Re: Correction to the Staff Report of Site Plan No. 82001009C, Milestone Business Park

MCPB No. 11-17  
Site Plan No. 82001009C  
Project Name: Milestone Business Park  
Hearing Date: February 17, 2011

**Staff Report: Limited Site Plan Amendment 82001009C, Milestone Business Park**

*Rendered Cross Section*

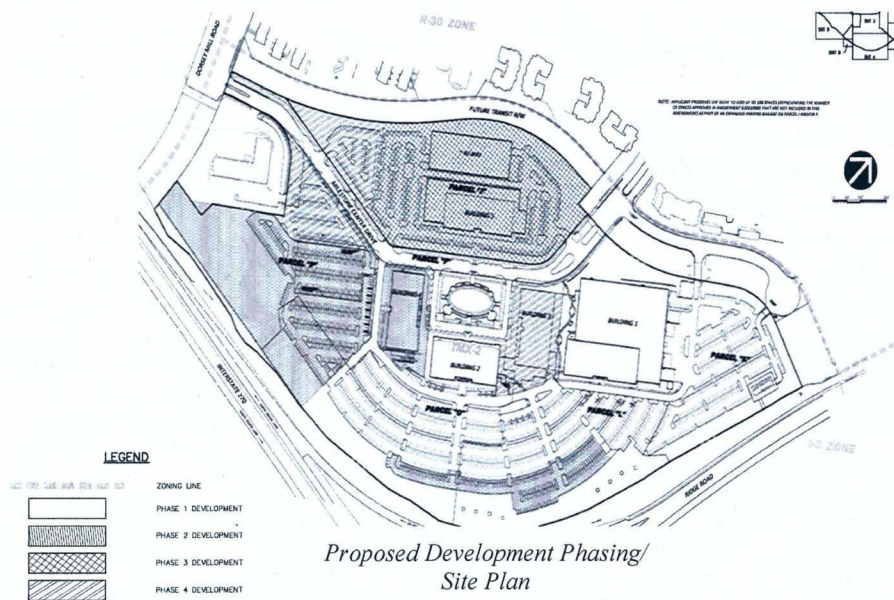
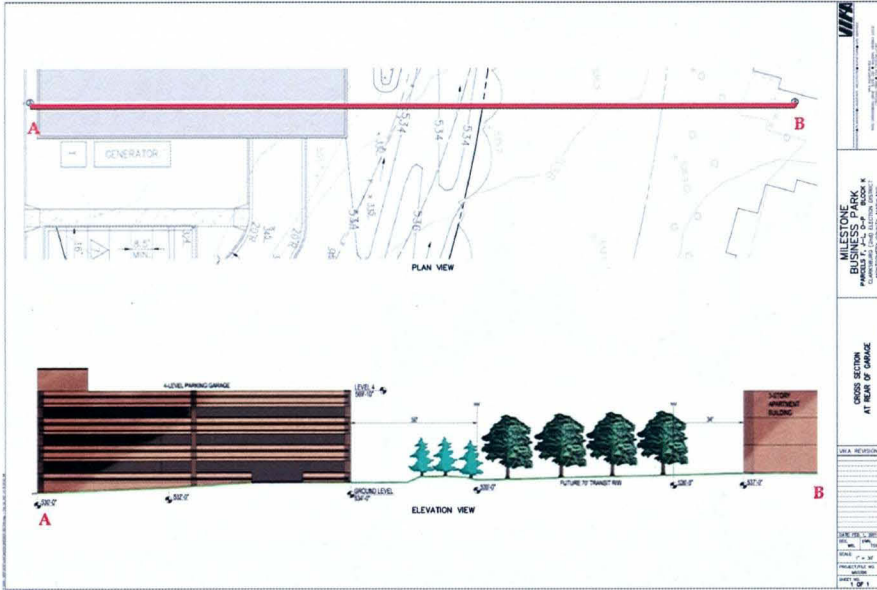
III. The construction of Phase III, Building 5 and associated parking facilities. The total density to be transferred to phase IV is 25,550 square feet; which will include the square footage permitted for the retail and restaurant uses. The construction of Building 5 will consist of office and light industrial uses only. The structural modifications to Building 5 include a reduction to the height by 1-story and to the area by 5,000 square feet. The structural modifications proposed for the parking garage included a reduction to the width of the building footprint by 76,013 square feet and an increase to the total height by 2-levels.

~~a-b.~~ The north side of the proposed parking garage must be completely buffered with dense evergreen trees from major views toward the residential units.

e. The maximum height of the light poles shall not exceed 23 feet including the mounting base. The light poles proposed on the top level of the parking garage must have a "pyramid effect" with the tallest light poles within the center of the parking facility. The light poles proposed along the perimeter of the parking facility shall not exceed 12 feet from the parking surface level to ensure no glare or excessive illumination abutting the residential properties.
